**TOWN OF HERNDON, VIRGINIA
PLANNING COMMISSION PUBLIC HEARING AGENDA
FEBRUARY 25, 2019
HERNDON COUNCIL CHAMBERS BUILDING
765 LYNN STREET
7:00 P.M.**

Subject: Development Plan Application, DP#17-01, 555 Herndon Parkway

This memo serves as an addendum to the Planning Commission staff report, dated February 11, 2019, which was considered by the Planning Commission in its review of the above referenced case at its February 11, 2019 work session. The applicant has since submitted revised application materials to address the issues raised by staff and the Planning Commission.

PRELIMINARY SIGNAL EXHIBIT

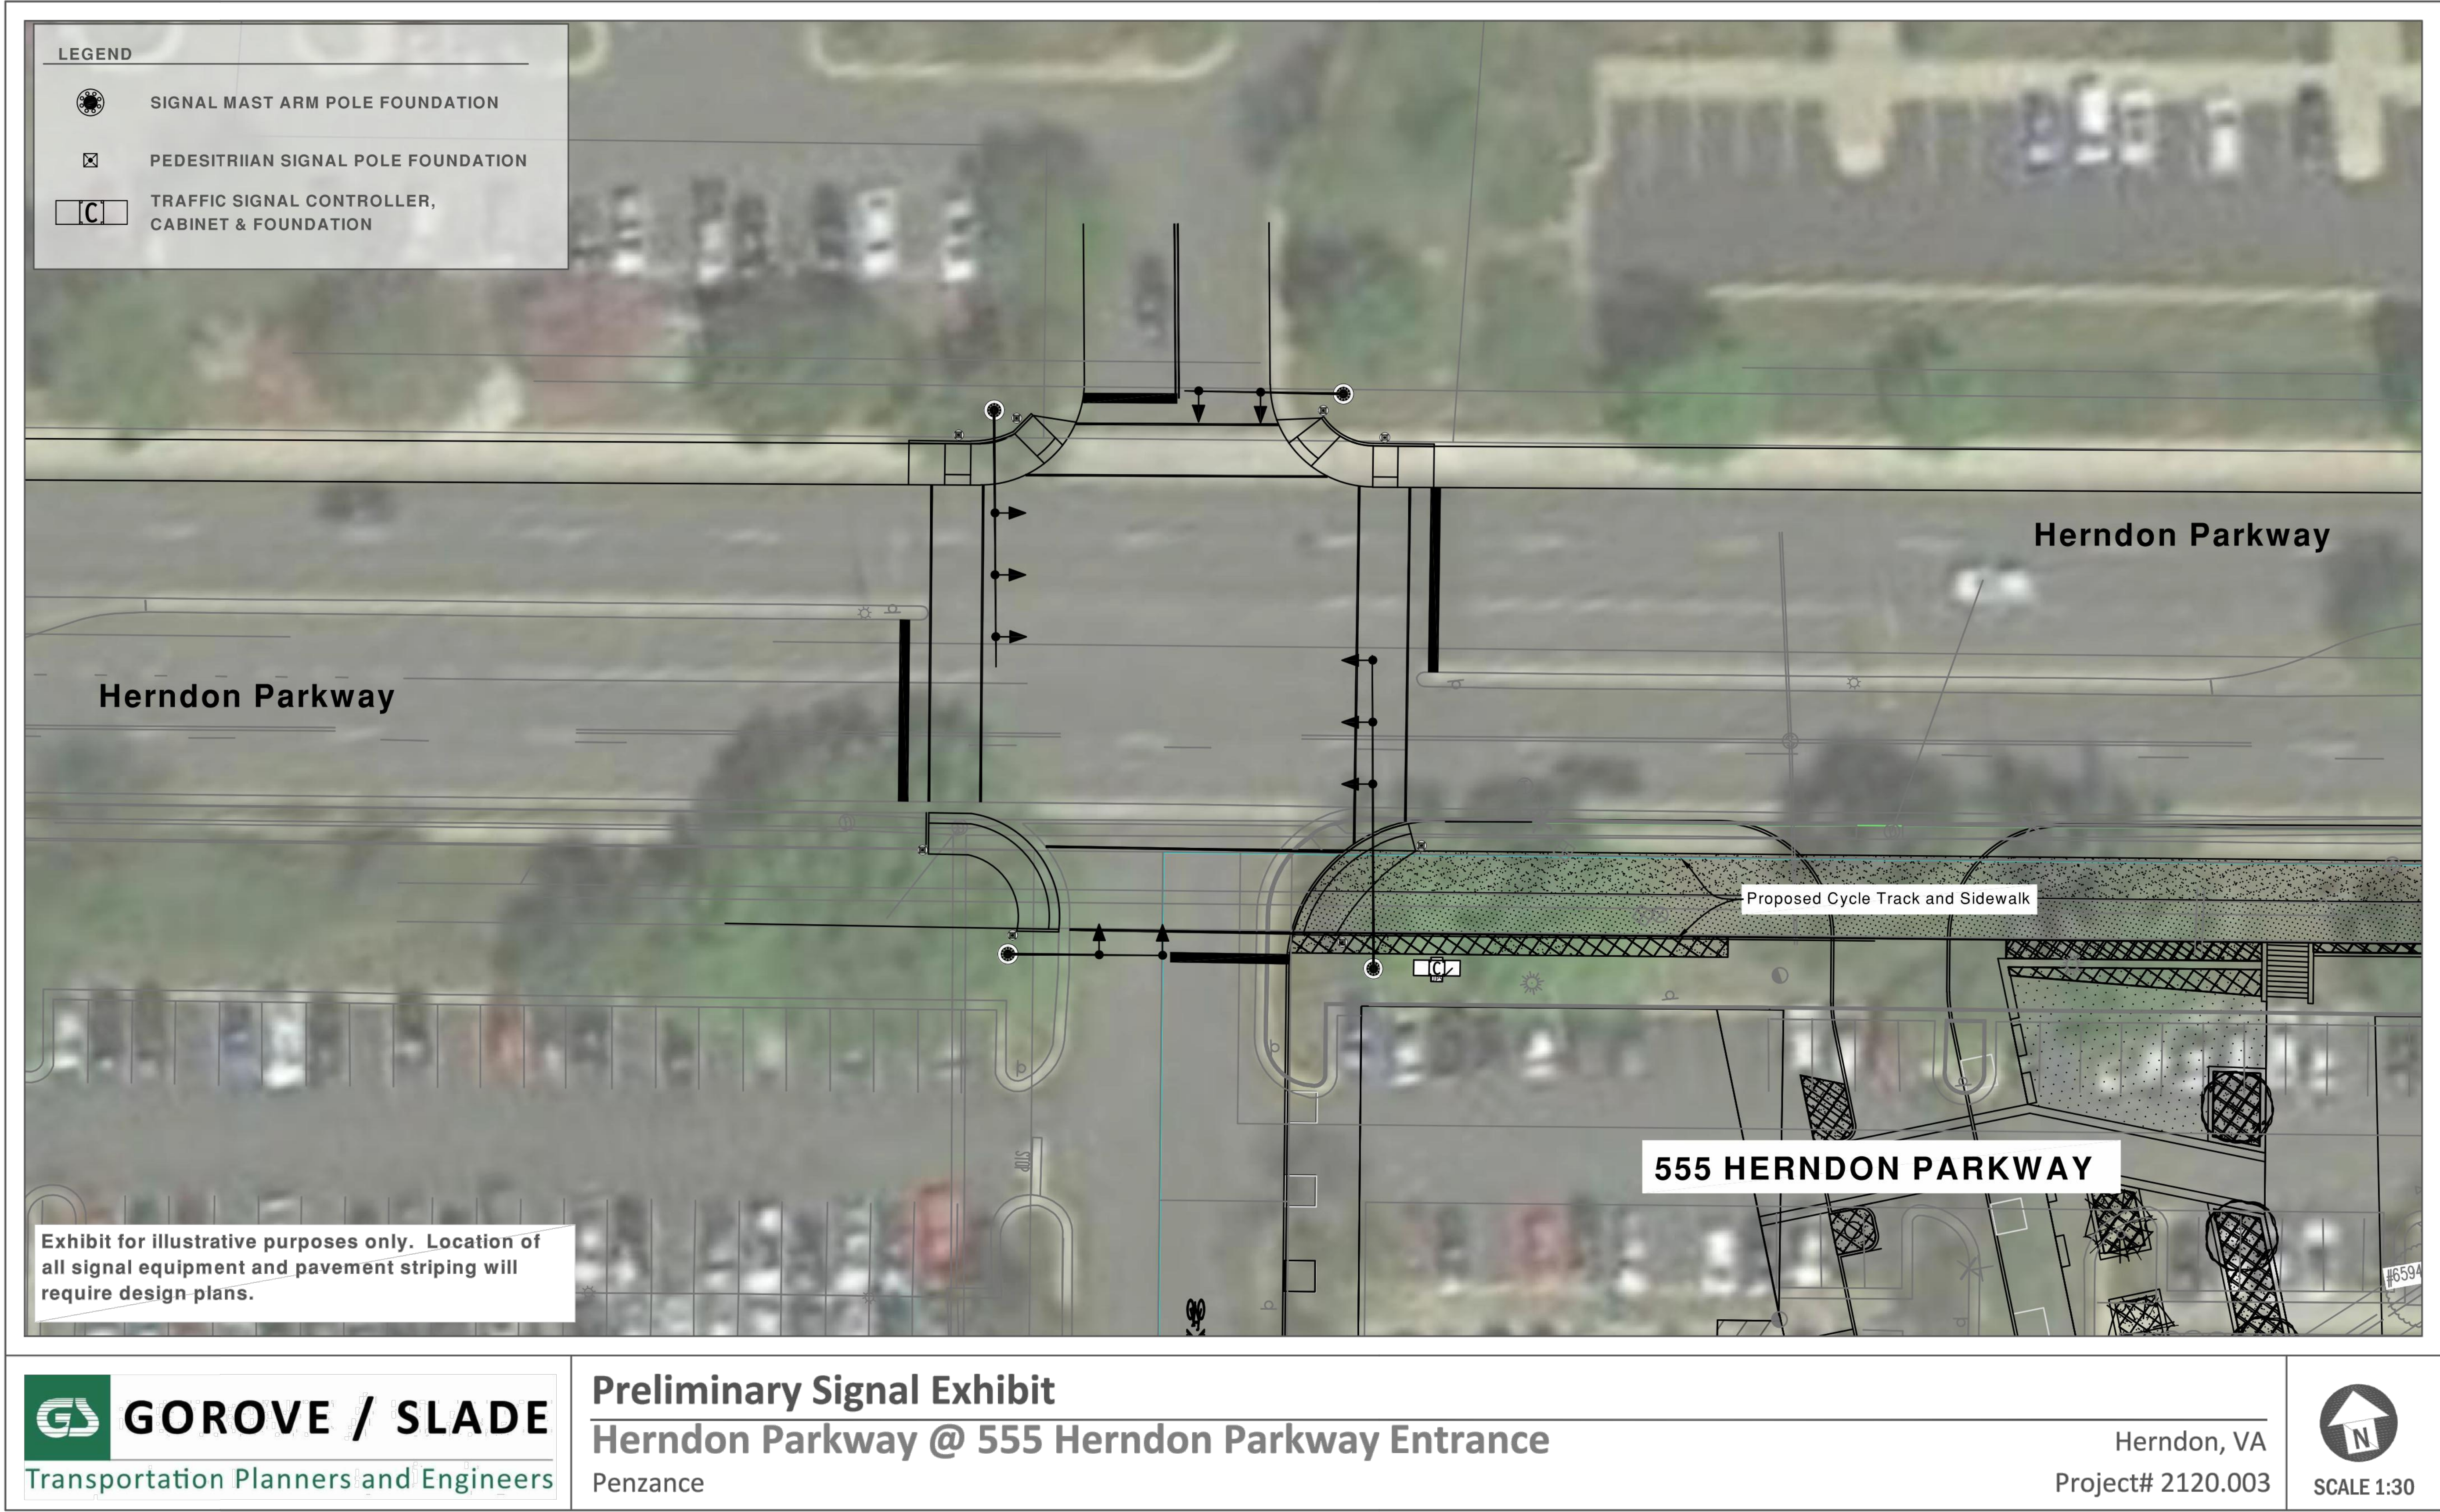
- An exhibit showing the conceptual design of the traffic signal on Herndon Parkway has been provided (Sheet 18.2).
- A sheet showing precedent images for stormwater management green infrastructure has been provided (Sheet 23.0).

3. Clarification on when traffic signal is warranted is being sought by staff. Staff is not questioning the findings that a traffic signal will be necessary at some point in the future, but wishes to obtain a definitive answer to when will the signal become necessary. The applicant is obtaining this information. The staff does not believe that this information is critical prior to Planning Commission action.

Z-1
SHEET 2 OF 7

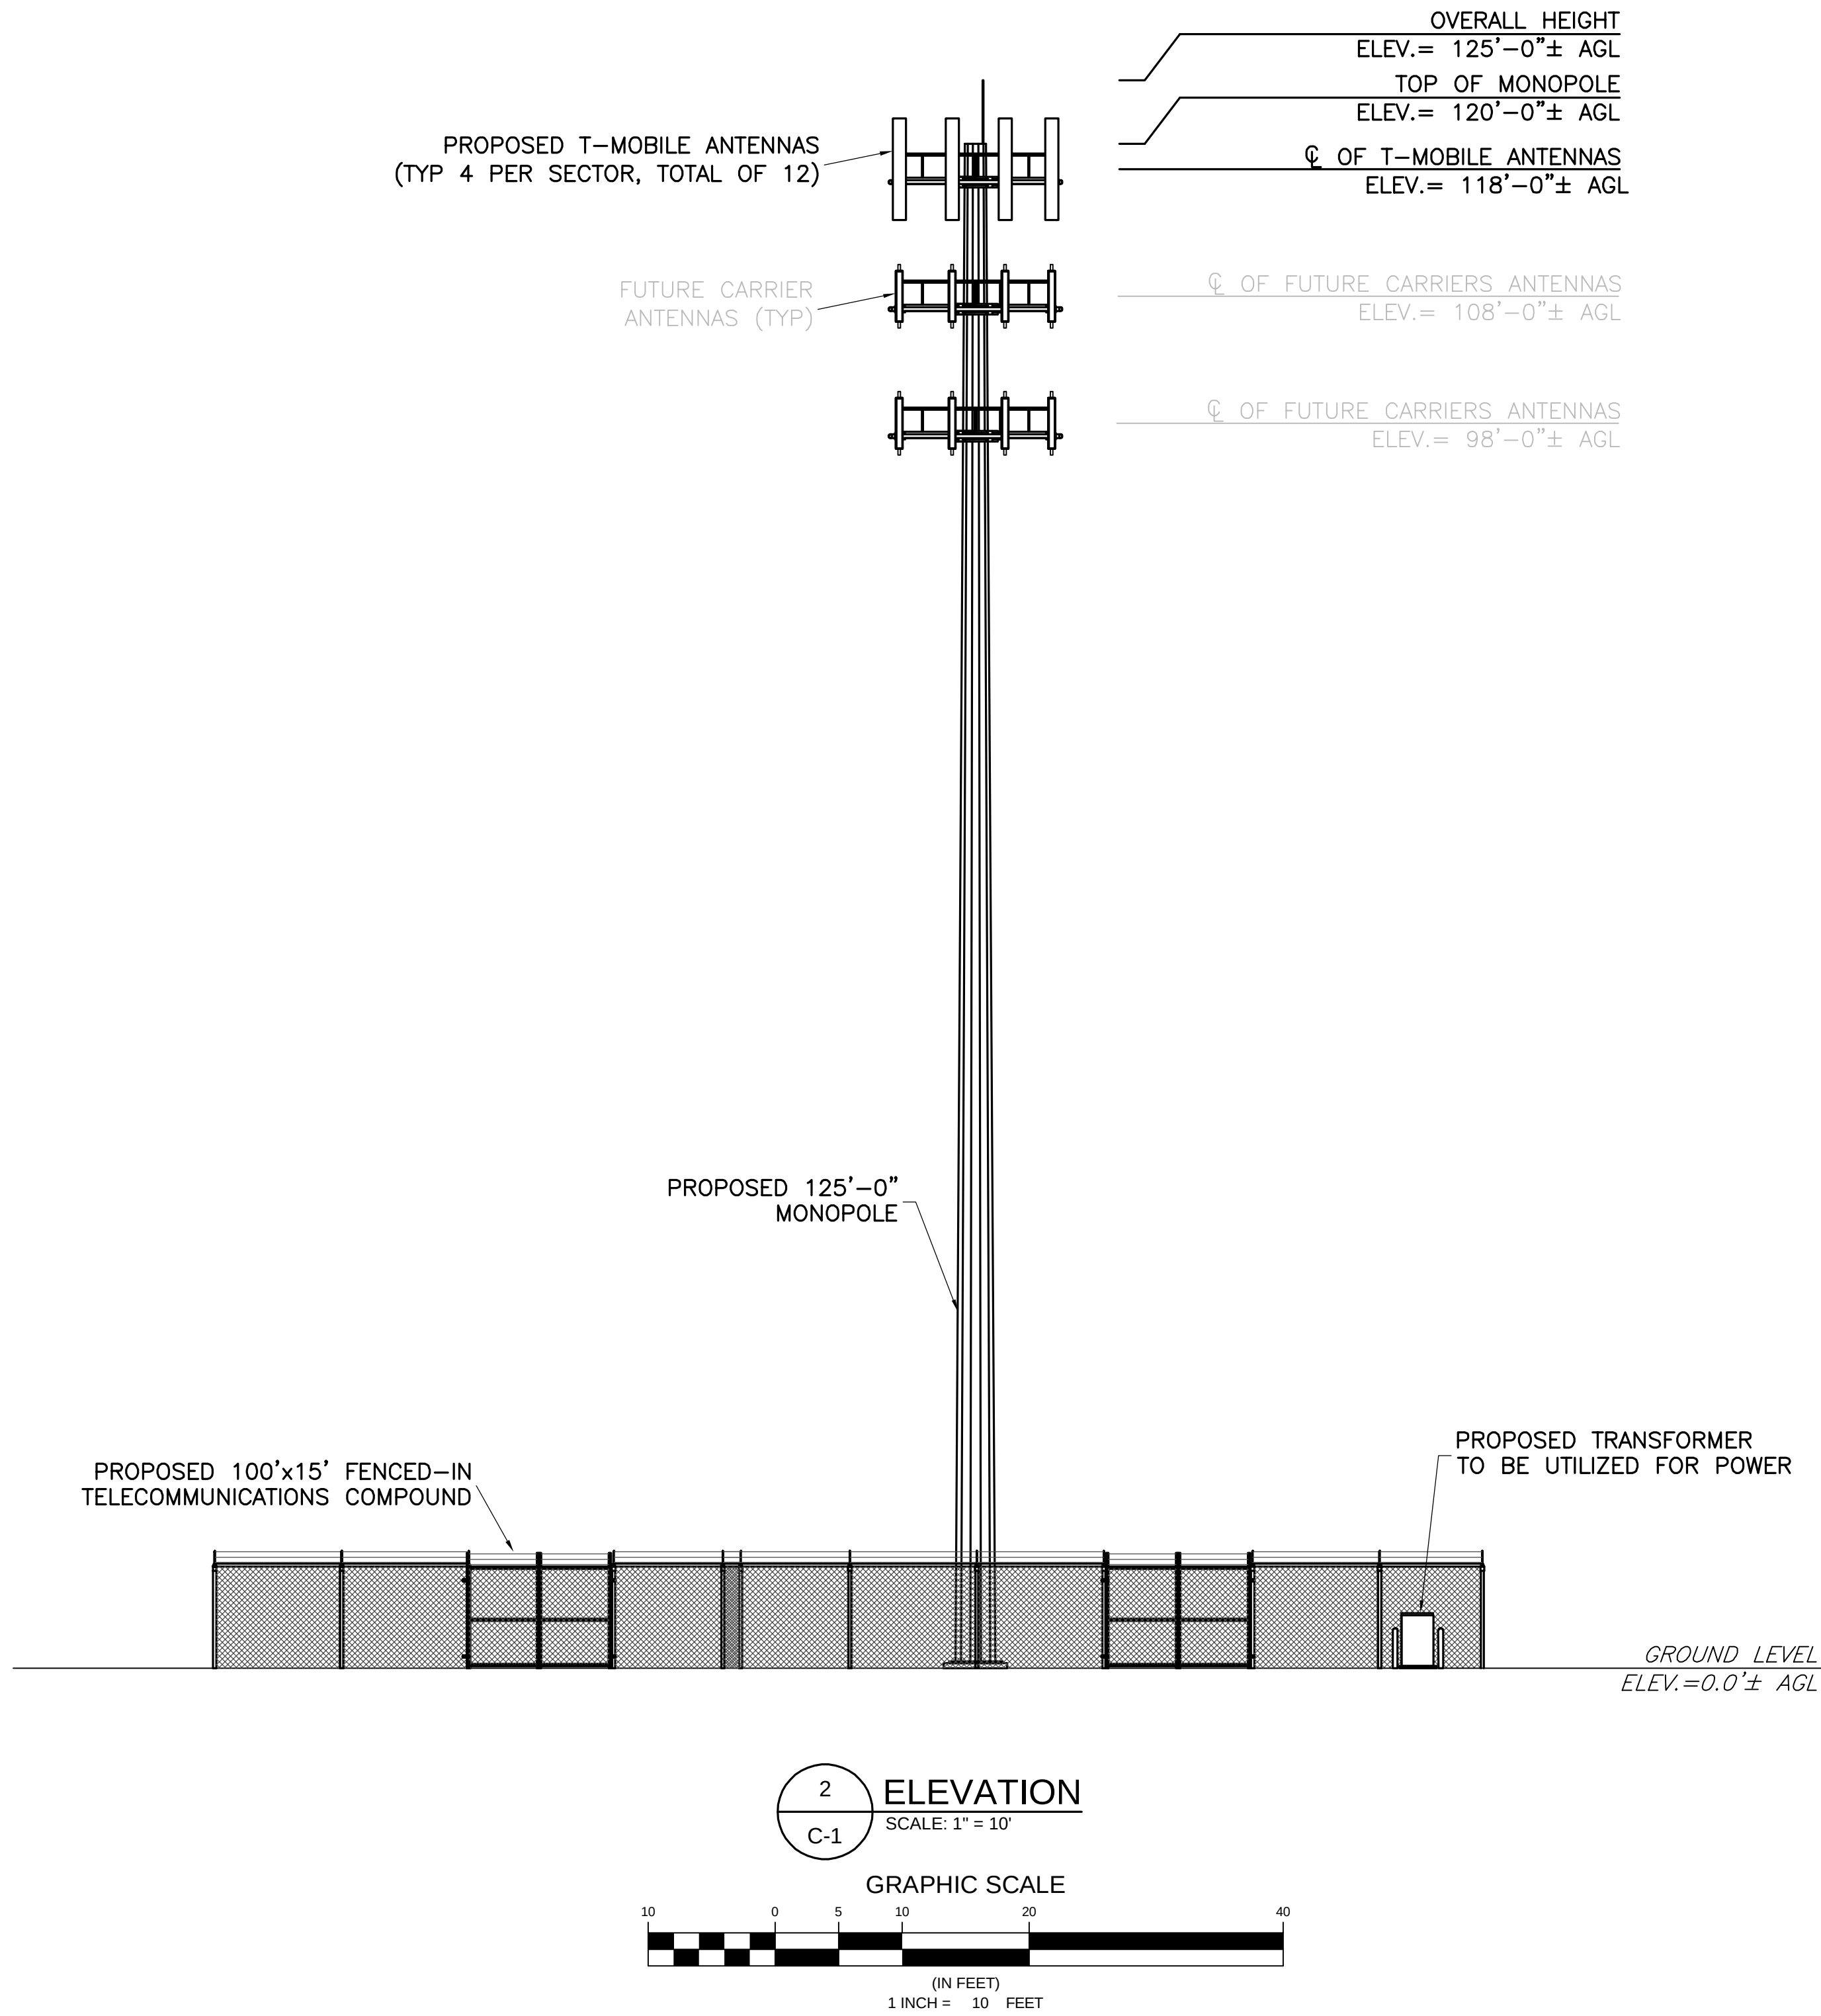
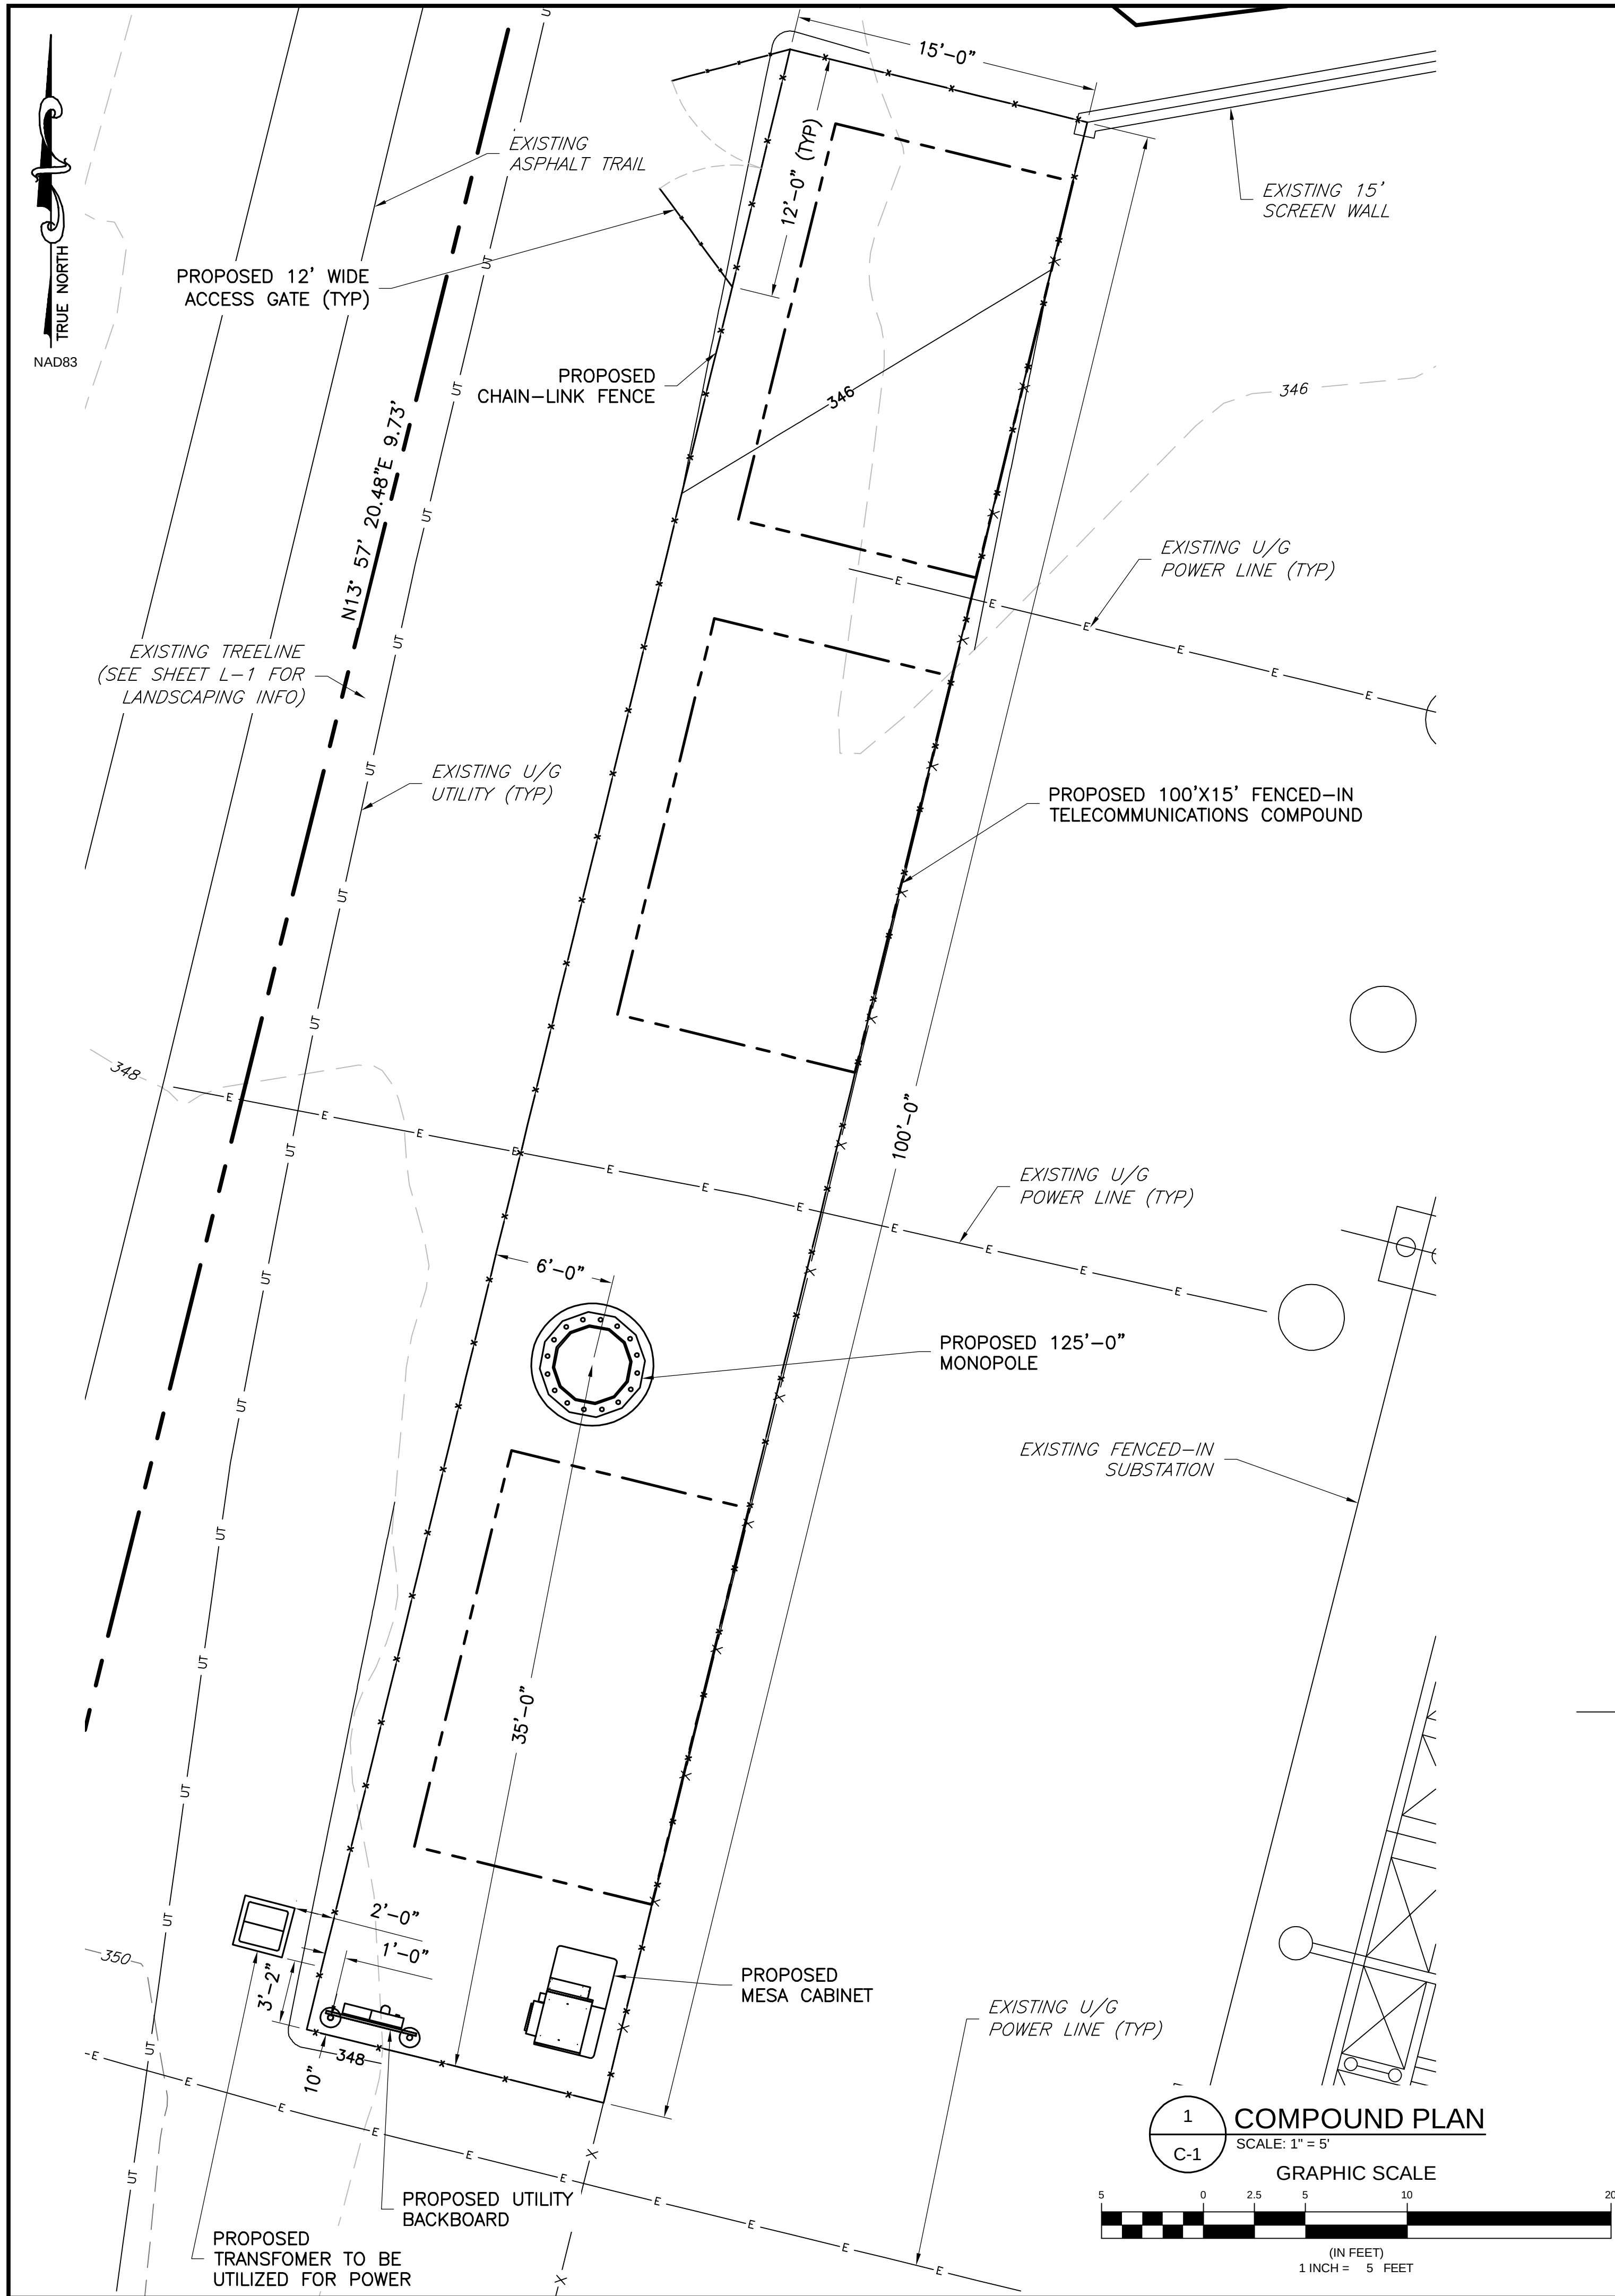
9. Fence elevation on sheet C-1 indicates two gates. This does not match with the proposed plan on sheets Z-1 and Z-2. It is recommended that only one gate be installed and with direct connection on-site to the internal access road.
